- VACUUM BREAKER 620243 HAS BEEN REPLACED BY NEW TYPE CODE 620535. BEFORE INSTALLING NEW VACUUM BREAKER FIRST CHANGE Ø21 TO Ø27

620535

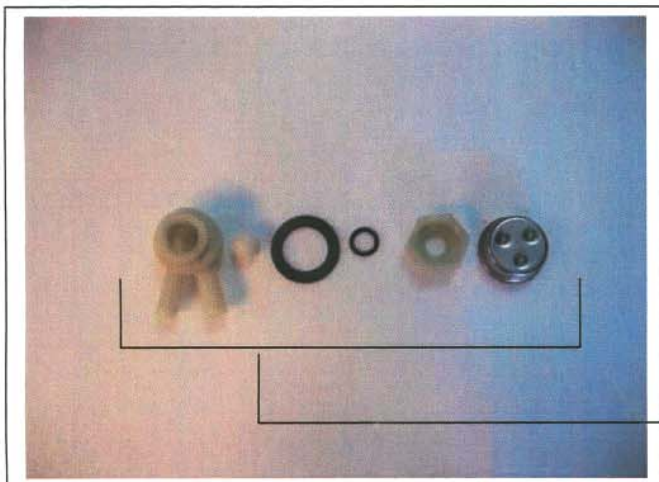
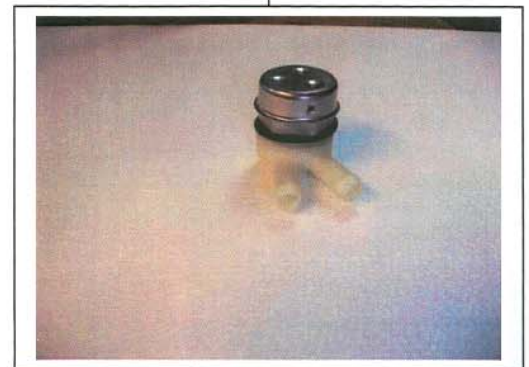
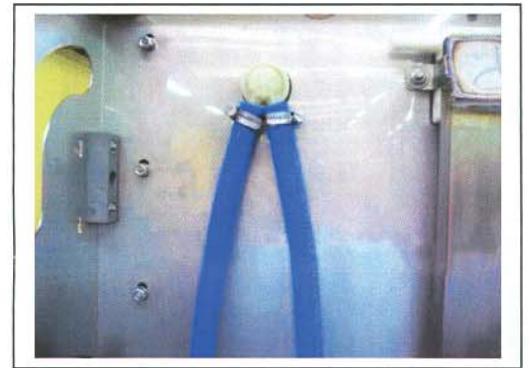
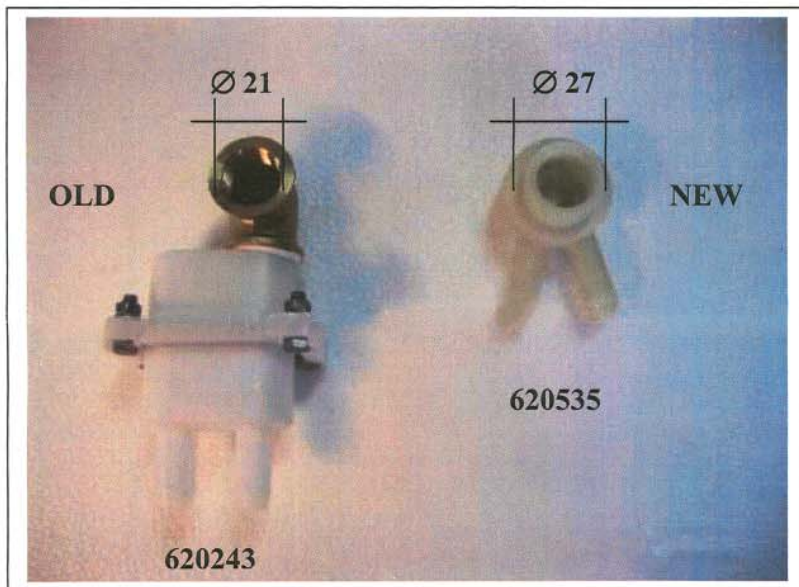
- LA VALVOLA ANTIVUOTO 620243 E' STATA SOSTITUITA CON IL NUOVO TIPO COD. 620535. PER IL MONTAGGIO ALLARGARE IL FORO DA Ø21 A Ø27

- ROHRTRENNER KODE NR.620243 ERSETZT DURCH KODE NR 620535. FÜR MONTAGE DAS LOCH BIS ZU Ø27 ERWEITERN

- LE CODE 620243 (CLAPET ANTIVIDE) A ETE REMPLACE PAR CODE 620535. POUR LE MONTAGE EVASER LE TROU JUSQU'A Ø27
